Australian Catholic University Concept Plan Modification 1 (MP10_0231-Mod-1) - Itemised response to DPPI queries

Following public exhibition, enquiries have been made by the Infrastructure Assessments team, Department of Planning, Housing and Infrastructure (DPHI). A detailed response to each of the questions raised is provided below.

Figure 1 - Comparison of approved and modified building envelopes

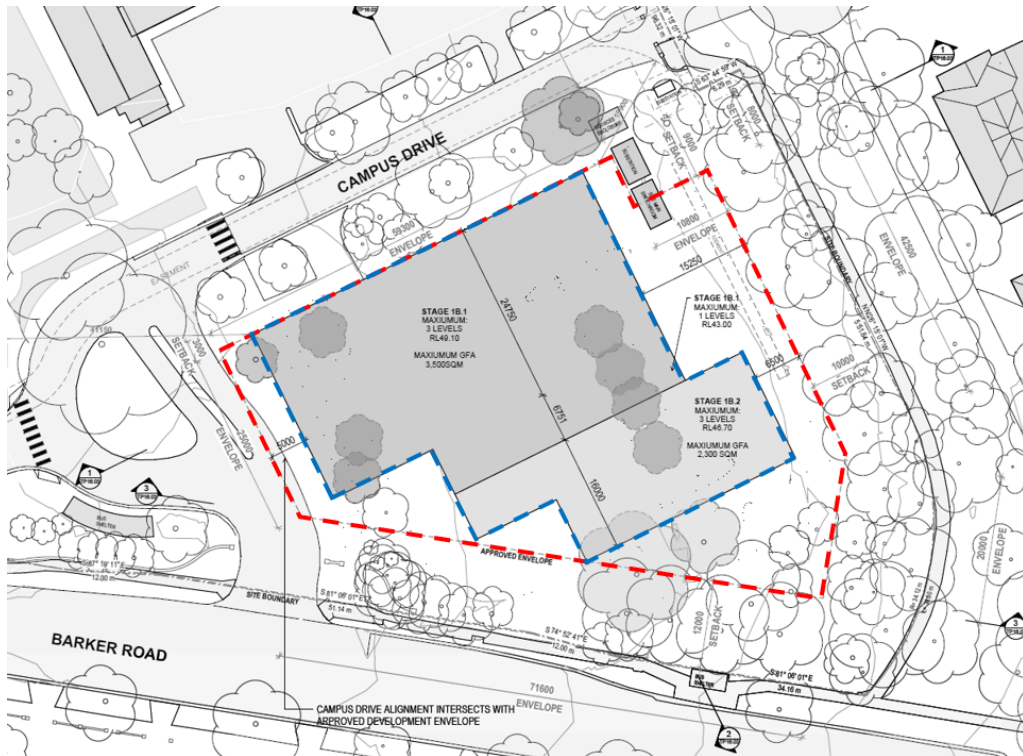
Building envelope setbacks

A comparison of the approved building envelope (as shown by the hashed red line) and the proposed modified building envelope (as shown in the dashed blue line) is provided in **Figure 1** below. It demonstrates that all building setbacks would be maintained or increased.

Figure 2 - Comparison of approved (left) and modified (right) building envelopes shadows (9am on winter solstice)

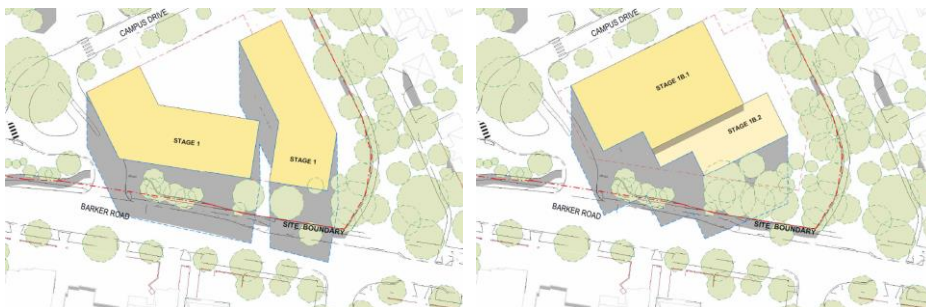
Overshadowing analysis

Shadow diagrams have been prepared for the approved and the modified Concept Plan for 9am, 12 noon and 3pm on the winter solstice as shown at **Figures 2-4** below.

The shadow diagrams demonstrate that the proposed modification does not impact any residential properties and has an improved impact on Mt Royal Reserve to the east at 3pm at the winter solstice, as compared to the impact of the originally approved building envelope.

Figure 5 – Location of trees proposed to be removed

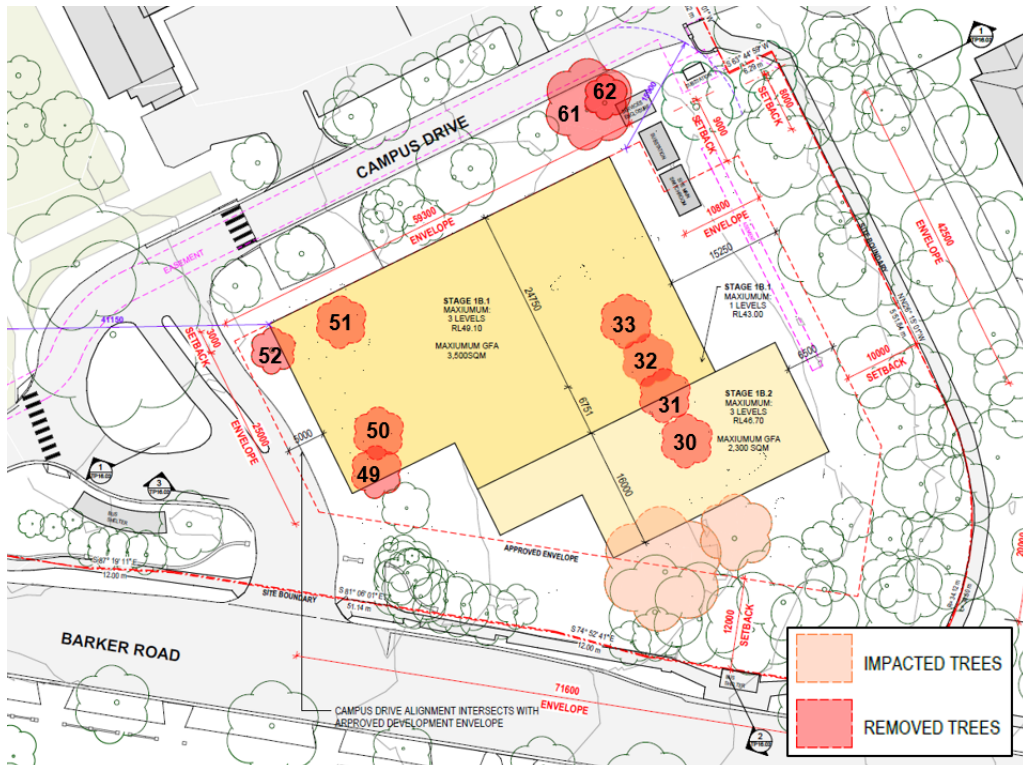
Tree removal

The location of the 10 trees to be removed is provided in **Figure 5** below.

The Arboricultural Impact Assessment prepared by Civica ArborSafe (11 November 2024) states that the seven *Phoenix canariensis* (Canary Island Date Palms) have the potential to survive transplantation. However, decisions regarding whether any of these trees, well as other trees with transplantation potential, are subject to detailed landscape design and expert cultural landscape advice at the Crown DA stage. Consideration would pertain to the usefulness of these trees in an alternative location, their health and likely longevity, the cost effectiveness of transplanting these trees, versus planting of new trees, including possible alternate species that are more appropriate to the First Nations and historical context. Accordingly, consent is sought for the removal of all ten trees without a commitment to transplant them.

Two of the trees proposed to be removed (T61 and T62) are located along Campus Drive and within the formal State heritage curtilage of *Mount St. Mary Campus of the Australian Catholic University*.
